ASSESSMENT REPORT

110-114 HERRING ROAD, MACQUARIE PARK MP 10_0112 MOD 8 and MP 10_0113 MOD 8

Figure 3: Approved access driveway (left) and proposed access driveway (right) (Source: Proponent)

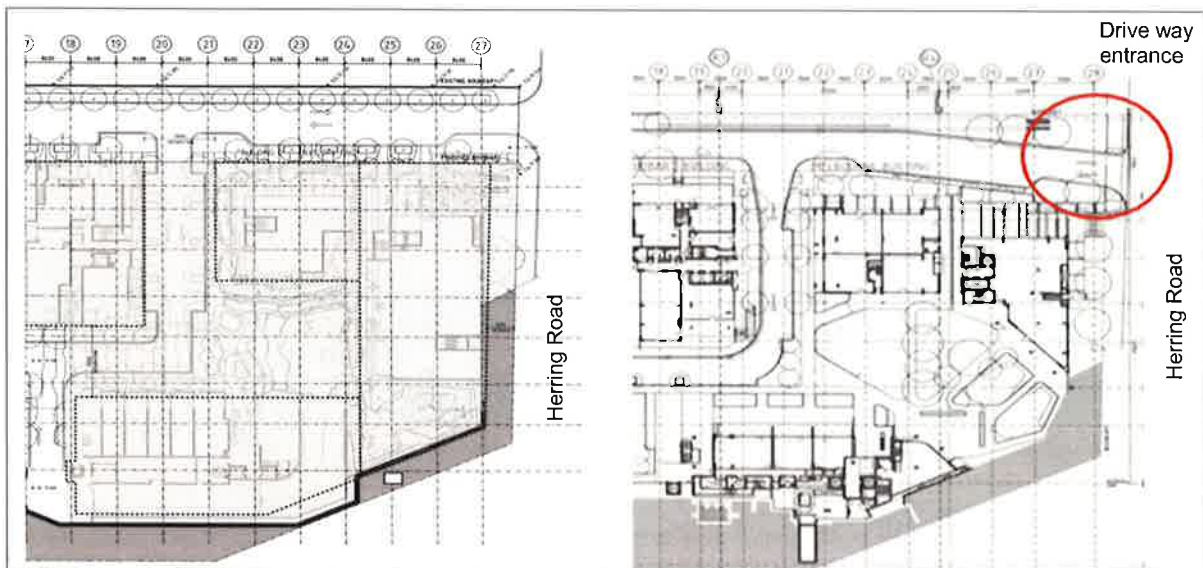
The modification to the entry alignment off Herring Road is required to retain access to Telstra's existing telecommunications services. Telstra will not permit construction of the driveway in the approved location as it requires clear access for maintenance at all times. Further, the frequent vehicular movement in and out of the site would potentially impact on the safety of maintenance staff working on these assets. Accordingly, the Proponent seeks to move the vehicle entry point approximately five metres to the south.

The proposed design retains the gradients of the previous access arrangement but will increase in width from six metres to 7.5 metres to assist with vehicles negotiating the change on the internal road.

In relation to the design of the revised driveway, the Statement includes a swept path analysis that confirms the ability of the new entry design to accommodate the largest design vehicle expected on site (a 12.5 metre heavy rigid vehicle) and the safe operation of the driveway.

Based on the findings of the Statement, the Department is satisfied the realignment of the

vehicle access on Herring Road and widening of the internal ring road would not adversely impact on traffic, access or parking. The Department recommends Condition A2 of the Concept and Project Approvals be updated accordingly.
